22 August 2023

ADDENDUM #02

PROJECT: Perryville Branch Library Renovation

E101B

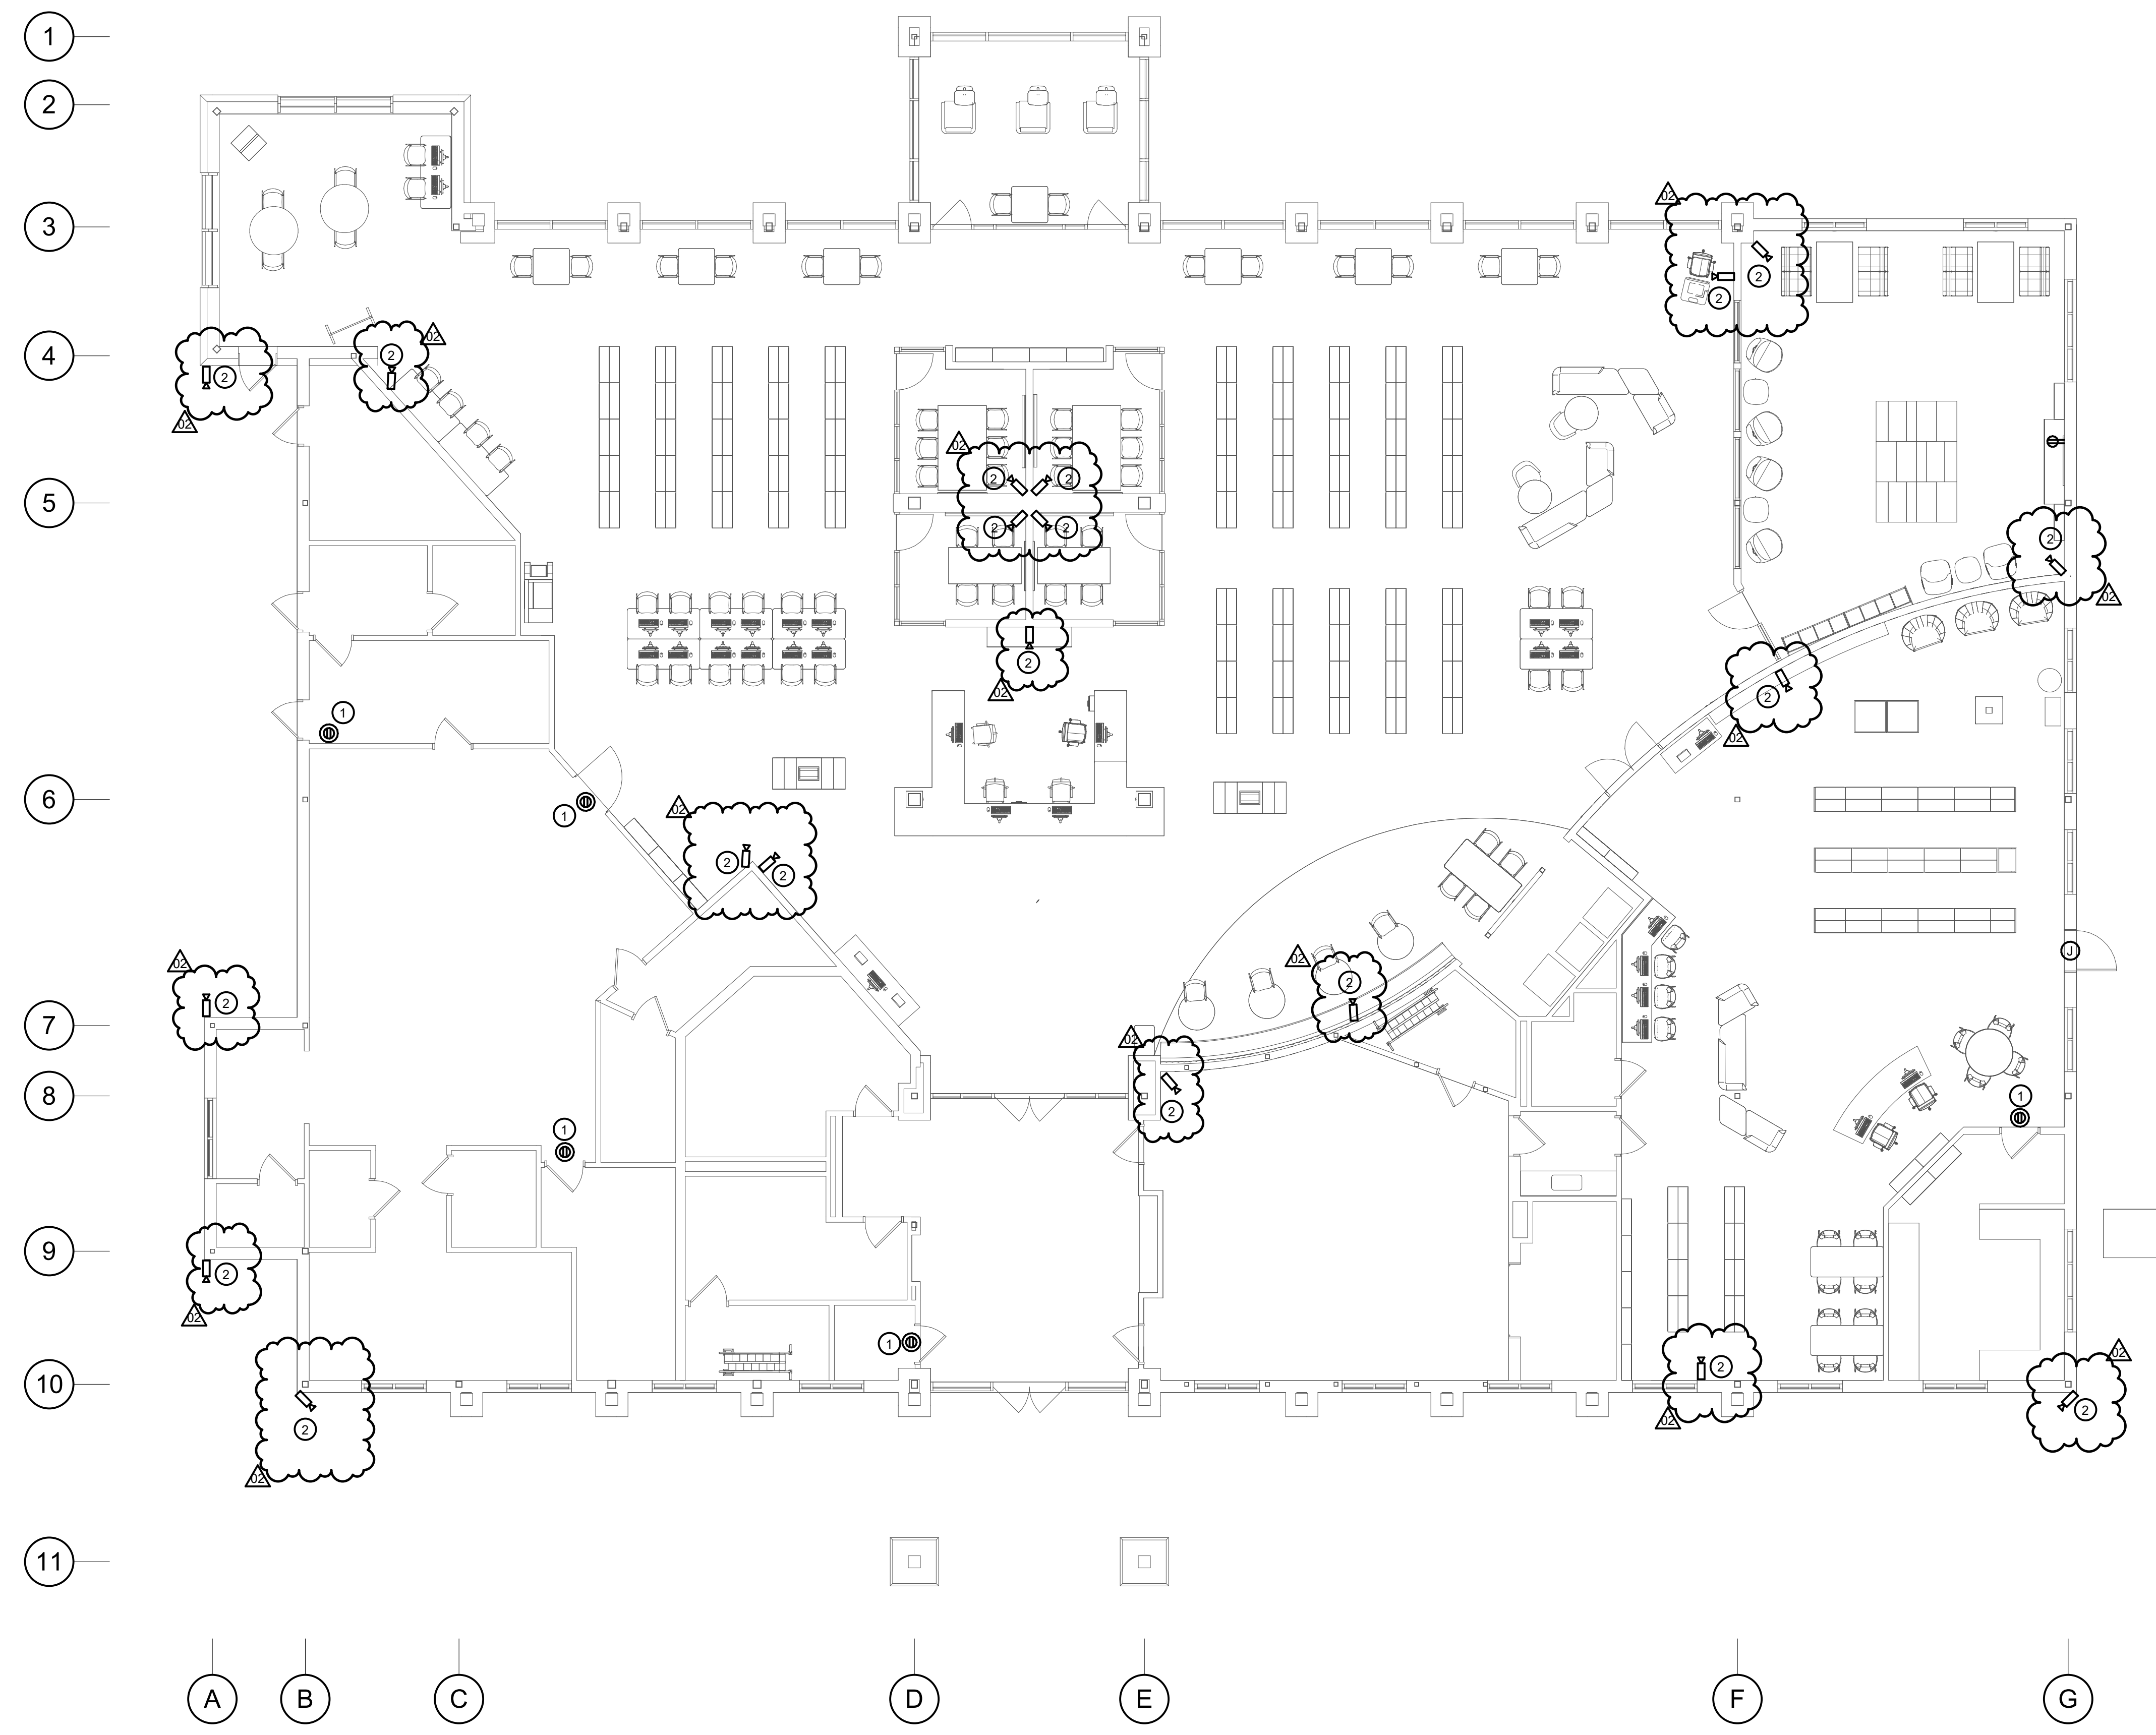
Answer: Security cameras and Card Access Controls will be provided and installed under separate contract by the Owner's Vendor. The pathways, data cabling, and power to support the security system equipment as indicated on Sheet E101B shall be provided under this contract.

REVISE Keynote #2 added to clarify scope of data cabling requirements for security cameras provided and installed by Owner's vendor.

- DUPLEX RECEPTACLE ABOVE ACCESSIBLE CEILING FOR ACCESS CONTROL'S POWER PROVIDED BY E-C.
- OWNER PROVIDED AND INSTALLED SECURITY CAMERA. PROVIDE CATEGORY 6A CABLE HOMERUN BACK TO NEAREST SERVER ROOM AND TERMINATE ON PATCH PANEL. CABLE SHALL HAVE 10' SERVICE LOOPS COILED UP AT EACH END WITH A TOTAL CABLE LENGTH NOT TO EXCEED 295'.
